Service-Information Motorcycle

Group: 46
Frame

April, 1992
46 037 92
(2520)

Installation of Engine Protection Bars - R100R

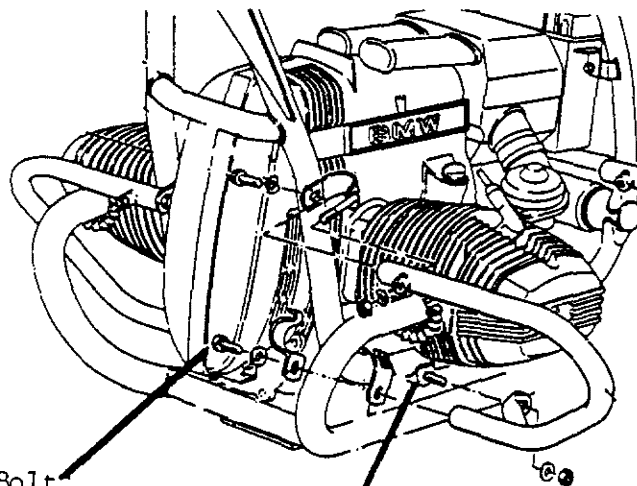
Information: Engine Protection bars incorrectly aligned, side stand contacts exhaust pipe.

Remedy: Flat washers included in the mounting set must be installed on the front engine mounting bolt prior to mounting engine bars. Install two washers on the left side (side stand side) and one washer on the right side.
